Technical Bulletin

Issue 10026 - Comline Fuel Filter Supersession

Matching the OE design, Comline EFF211 features a 'zig-zag' media surface area in comparison to EFF248D

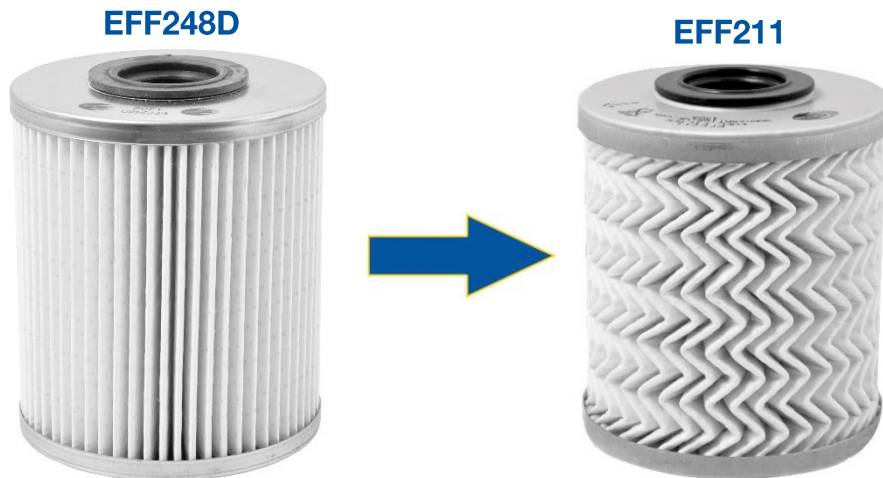
The new Comline part number, **EFF211**, features a larger media surface area in comparison to its predecessor. The redesign was essential to ensure the redesign matches the OE specification with 'zig-zag' rather than straight media pleating. Not only does the enhancement matchup to the latest OE design, the new part number's greater surface area, a direct result of the new 'zig-zag' media pleating, will allow EFF211 to increase its dust holding capacity, increasing the filter's efficiency and longevity.
